**ADDENDUM NUMBER:** Three (3)  
**DATE:** February 3, 2026  
**PROJECT:** Interior Renovations for Montgomery County Assessor of Property  
**DESIGNER:** DOUGLAS A. JONES, ARCHITECT  
 MONTGOMERY COUNTY ENGINEERING  
**BID OPENING:** February 10, 2026, at 2:00 P.M.

**TO PLANHOLDERS:** This addendum is issued to modify the original Project Manual and Project Drawings dated January 14, 2026, and is hereby made part of the contract documents. Acknowledge receipt of this Addendum in the space provided on the Bid Form. Failure to do so may subject the Bidder to disqualification.

CEILING DEMOLITION PLAN  
INTERIOR RENOVATIONS FOR  
MONTGOMERY COUNTY ASSESSOR OF PROPERTY  
350 PAGEANT LANE, SUITES 401 & 402  
CLARKSVILLE, TENNESSEE

POWER/SYSTEMS FLOOR PLAN  
INTERIOR RENOVATIONS FOR  
MONTGOMERY COUNTY ASSESSOR OF PROPERTY  
350 PAGEANT LANE, SUITES 401 & 402  
CLARKSVILLE, TENNESSEE

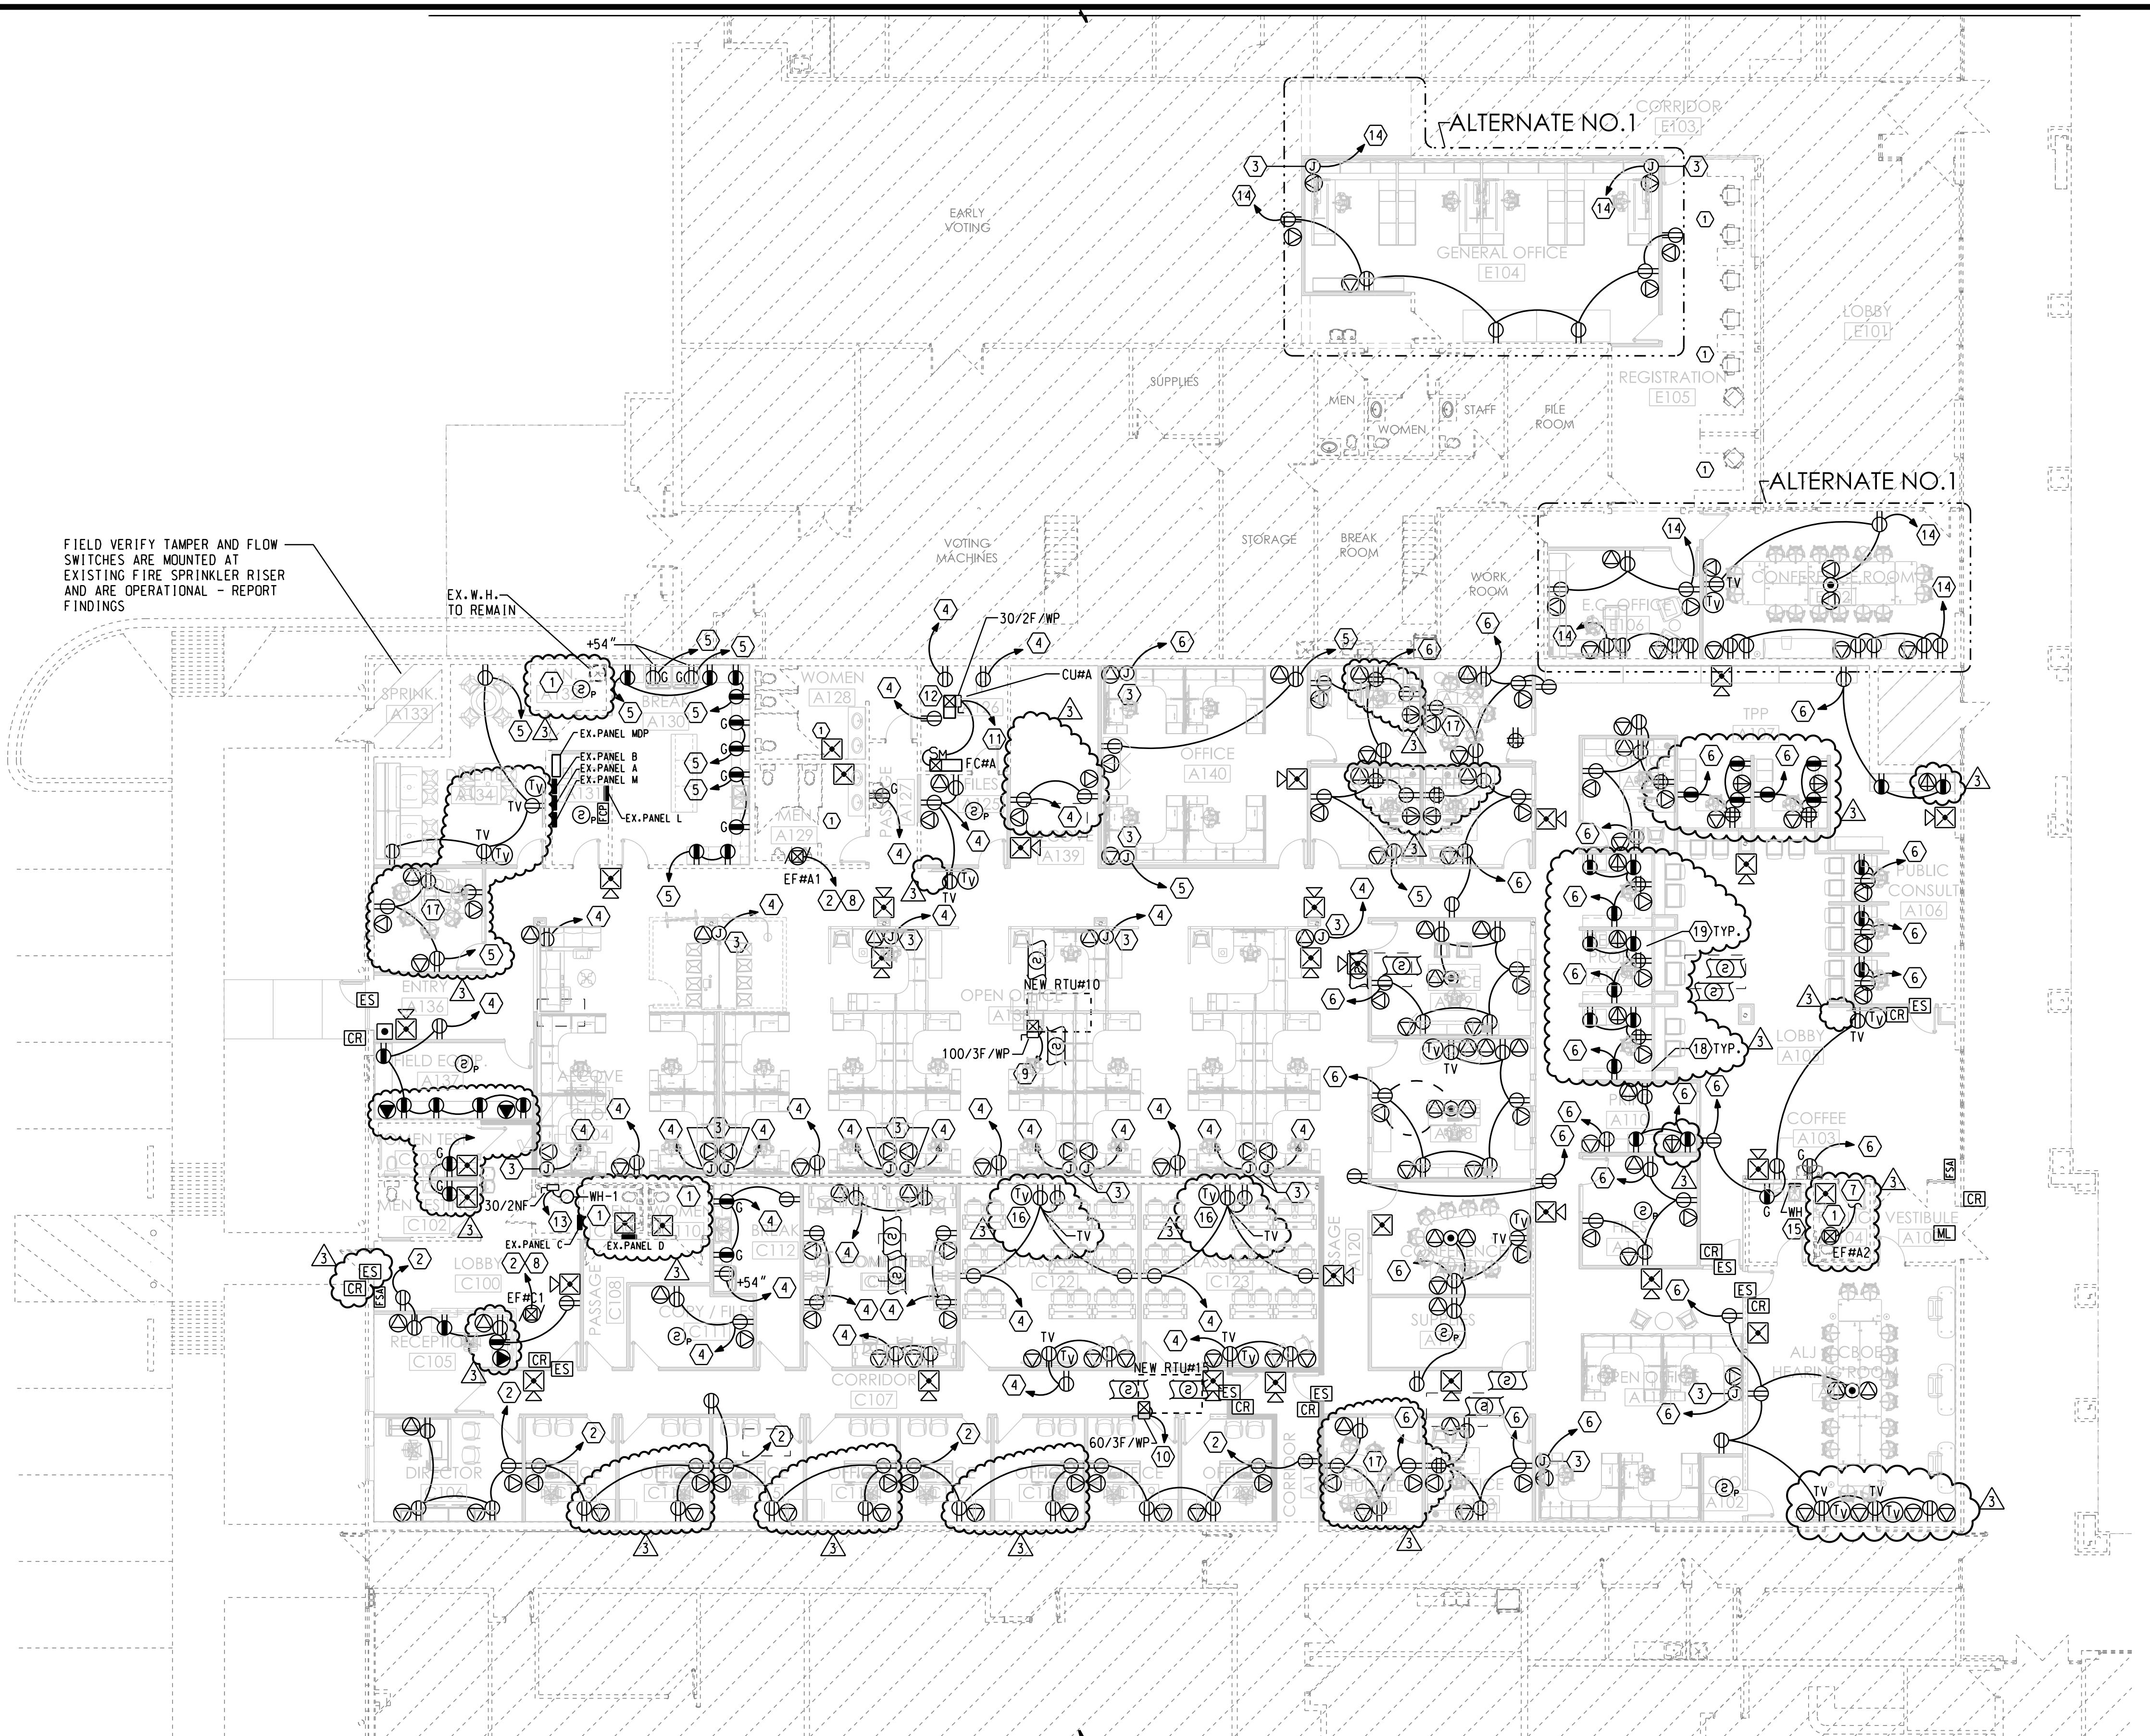
SHEET E-2 POWER/SYSTEMS FLOOR PLAN; Delete Sheet E-2 dated 01/14/2026 and Substitute Therefor Sheet E-2 Dated 2/3/2026 attached hereto.

Clarification: General Electrical Revisions & Replacement of Existing Fire Alarm system.

**Q:** On Sheet E-2 there are some symbols shown that do not appear in our electrical legend. They are shown as squares with letters [CR], [ES] & [ML]. Please clarify what these symbols represent and if they are just being shown so the electricians can provide a raceway for these devices? If we are to provide a conduit raceway, what size will be required? These appear to be security devices, will the owners provide and install the low voltage wiring and the security devices that are shown?

**Q:** What type of floor box will be spec'd?

**A:** CR, ES, & ML are Card Reader, Electric Strike, & Magnetic Lock respectively. Conduit & boxes are required to be installed by the contract. Requirement shall match Data Box detail. The Owner will install cabling & devices not specified in the hardware schedule. Refer to items 12 & 13 above.

**A:** Basis of design is ABB model 643 3 gang floor box. Contractor shall not provide separate floor boxes for power and communications. Refer to Item No. 13 above.
